ADDENDUM: 2

Project: City of Moore, Vermeer Sign Shop & Streets Breakroom

**Project No: TAP Project No. 2516
City of Moore Project No. 2026-009**

Date: February / 09 / 2026

Garage Mate Compact Single-Stage Air Compressor

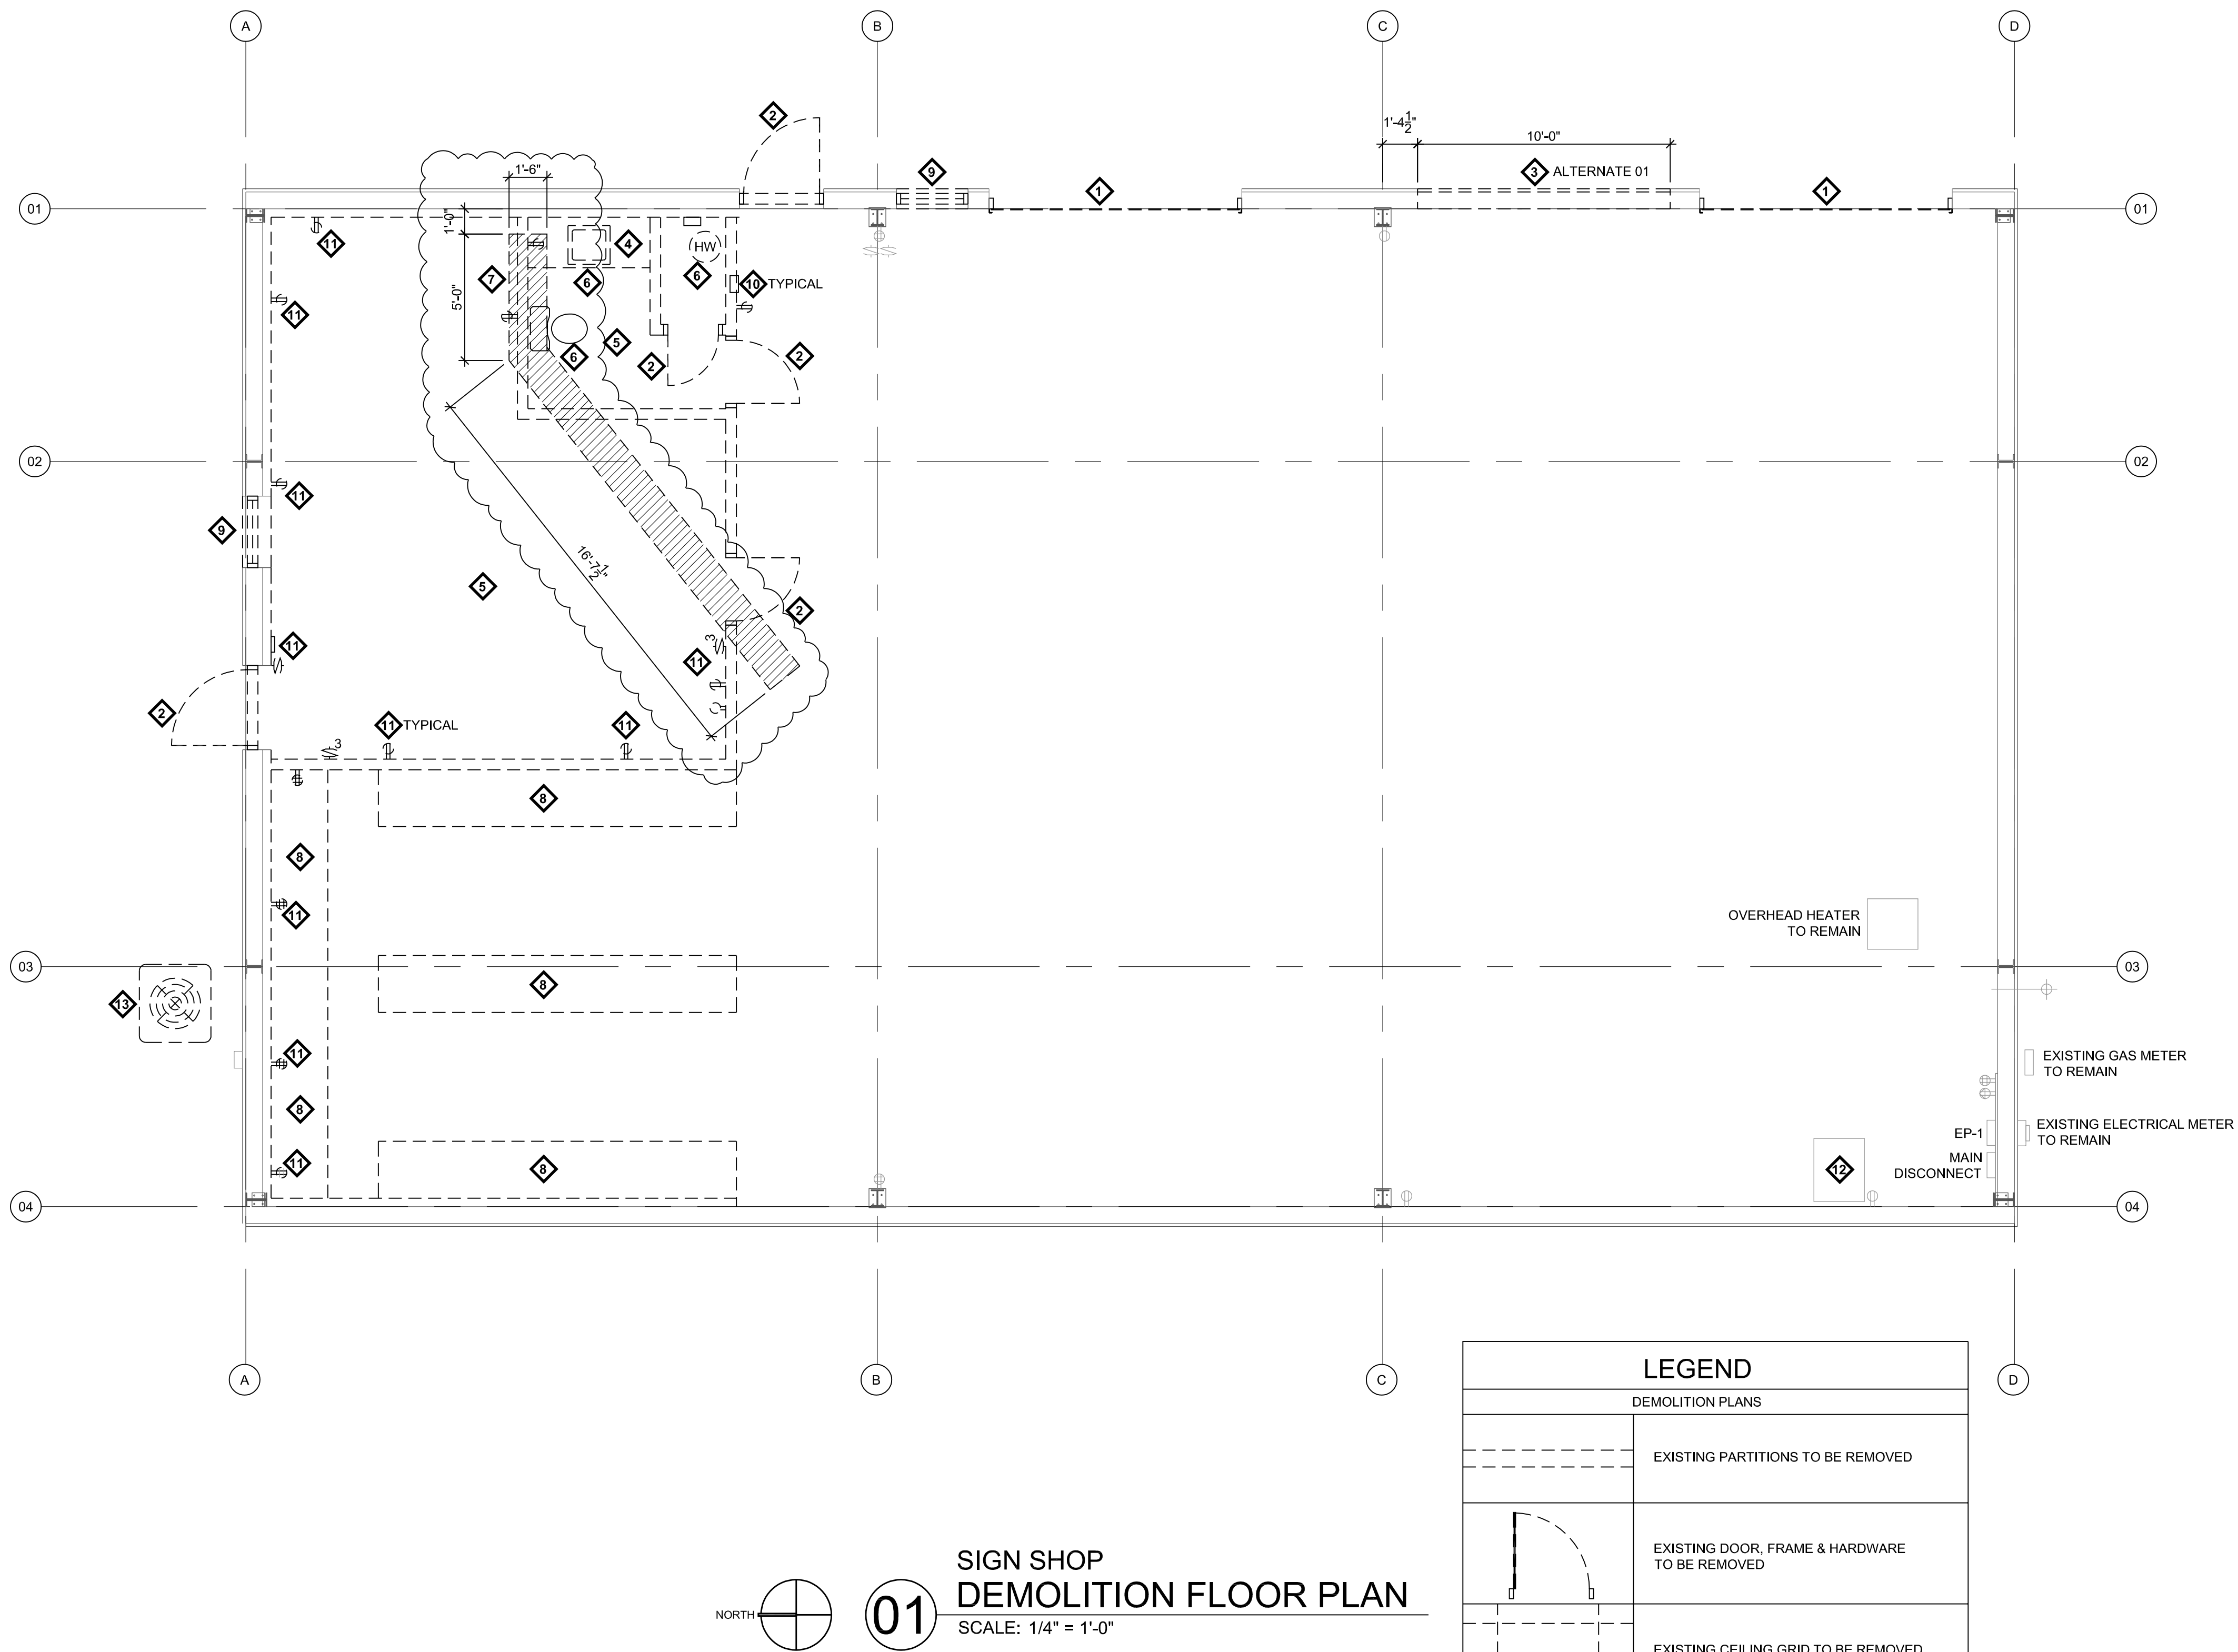
A1.2.1 Refer to Attachment – provided Basis of Design for the air compressor.

A1.6.3 What is the size of the air compressor?

ANSWER – See provided cut sheet on the air compressor specifications. Contractor to include in their base bid, 20' of air hose extension to the piece of equipment (Handyman Squeeze Roll Machine).
